Response to DEQ 12/18/2020 Additional Information Request

Re: Joint Permit Application Number 19-2036, Wegmans Distribution Center, Hanover County, Virginia, Additional Information Request Letter (dated 12/18/2020).

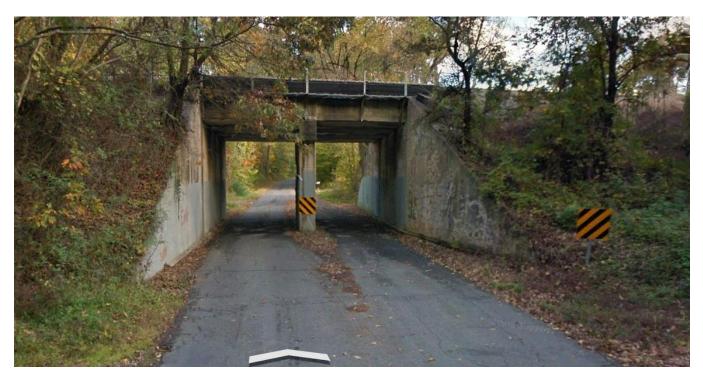
2. In review of public comments received on the draft permit, DEQ has learned that prior to submitting an application for construction of the project at the Air Park site, a Letter of Intent (LOI) was executed with the property owners of Alternative 4 - Graymont. Please provide additional information regarding the LOI and information relevant to the decision that Alternative 4 did not represent LEDPA.

To conduct site due diligence on the parcel, the Applicant provided a letter of intent to the property owner in the fall of 2019. With the LOI in place, the Applicant and their consulting engineers were allowed to conduct due diligence investigations on the site (mussel surveys, Geotech borings, etc.). These investigations, along with preliminary engineering analysis, facilitated the identification of engineering site constraints, necessary offsite improvements, feasibility of future expansion, as well as other potential roadblocks to the development process. As a result of their due diligence the Applicant determined the site was not practicable for a multitude of reasons, such as:

- Estimated \$8.75M in road improvements to Elletts Crossing and Hickory Hill
- Required sanitary sewer pump station along with approx. 2 miles of 8" sanitary force main

- Results of Geotech borings pointed to potential additional engineering constraints with respect to the subsurface and building foundation depths
- Limited with respect to future site expansion
- Necessary \$2.8M site retaining wall
- Potential architectural historic resource (Colonial Revival-style dwelling)

In addition to the items listed above (and those previously submitted) regarding Graymont , truck access to route 1 would be potentially risky due to safety concerns associated with the railroad overpass of Elletts Crossing Road (see image below).
